Fulton County, GA

**Re: 12ITB81746K-REV-JAJ  
Construction Services for the Department of Water Resources**

**12ITB81746K-REV-JAJ**  
**Construction Services for the**  
**Department of Water Resources**  
**Addendum No. 3**  
**Page Two**

This Addendum forms a part of the contract documents and **modifies** the original ITB documents as noted below:

DRAWING TITLE: FUELING DETAILS - SHEET 1  
 DRAWING NUMBER: M-401  
 DRAWN BY: AJD  
 DESIGNED BY: KLL  
 CHECKED BY: TDG  
 PROJECT NUMBER: 2015-0021

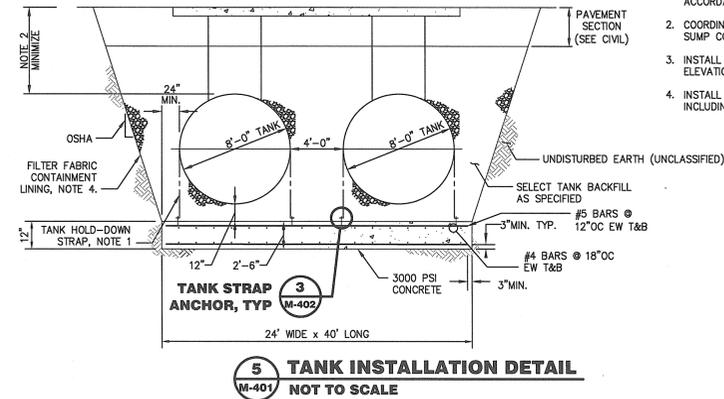
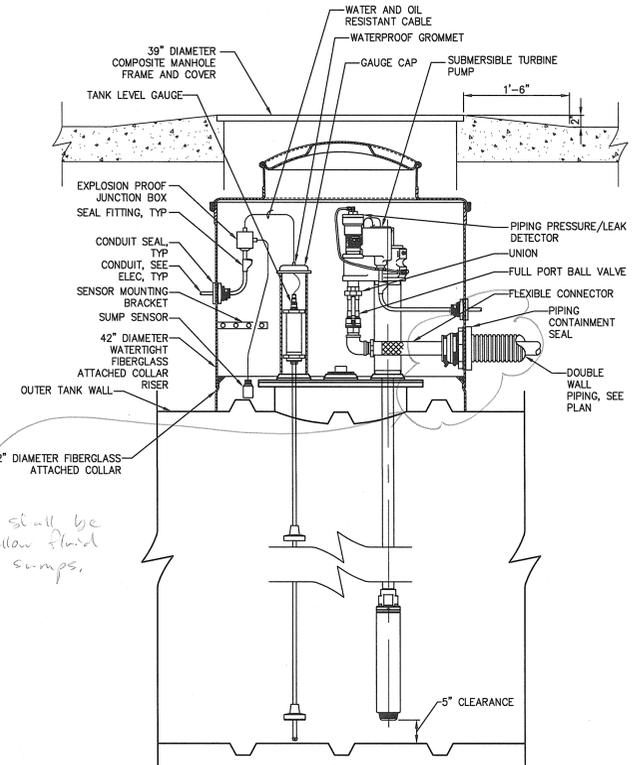
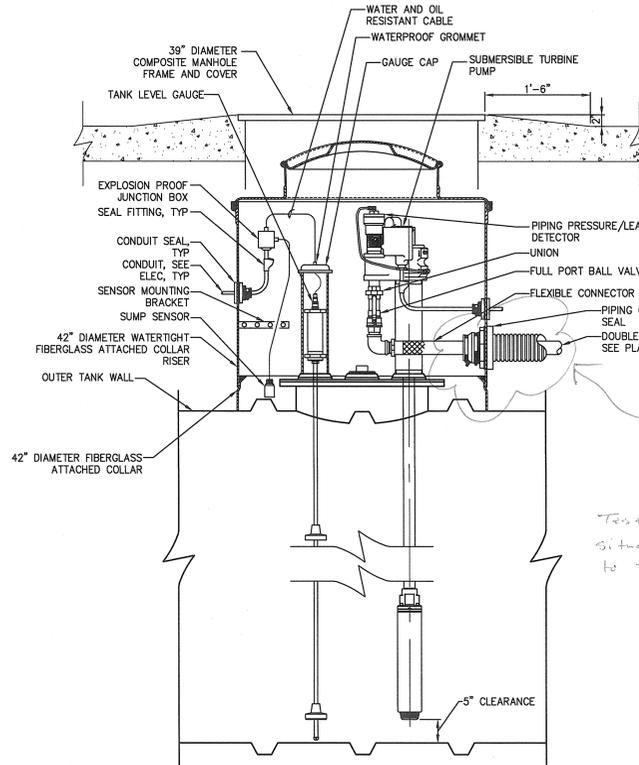
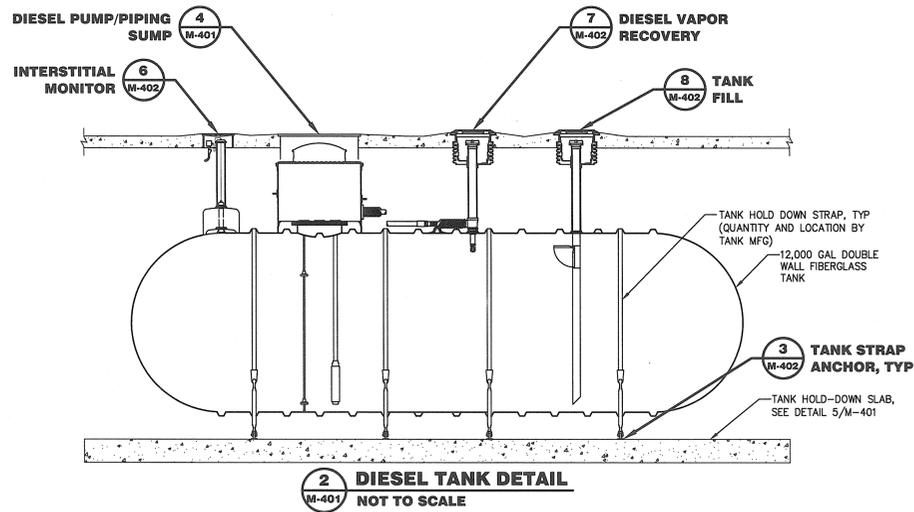
1. **Question:** Reference Drawing Detail 5/ M401 Underground Fuel Tanks – What is the minimum cover required over the top of the fuel tanks? Note 2 says to refer to the pipe containment sump cover requirements, but minimum cover requirements are defined.

**Answer:** The minimum cover from the top of the tanks to the top of the pavement is 3'-0".
2. **Question:** Pre-engineered buildings always include dead weight of the building and roofing. Do we use 10 PSF collateral load or 5 PSF collateral load?

**6** INTERIOR ELEVATION WOMEN'S RESTROOM 187  
 SCALE: 1/4"=1'-0"  
 NOTE: SECOND FLOOR RESTROOM 273 SIM.

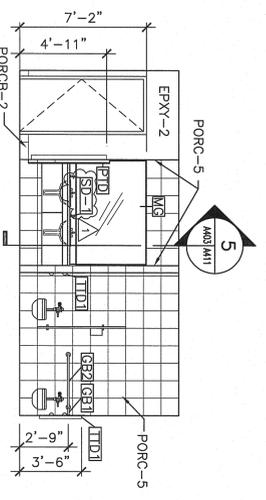
**50. Question:** On drawing A-404, Elevation 6, wall tile is not shown. Is this the designer's intent? If not which specific wall tile should be included for this work?

**Answer:** On Sheet A-605 in the Finish Schedule, add the following: At Room 139A Women's Toilet Room: Floor PORC -4; Base PORC B-2; North Wall Material PORC-5,6/EPXY-1; South Wall Material PORC-5,6/EPXY-1; East Wall Material PORC-5,6/EPXY-1; West Wall Material PORC-5,6/EPXY-1; Ceiling Material GYP, Finish PT-6; Remarks, Refer to Sheet A-404 for Elev/A-401 for enlarged plan.
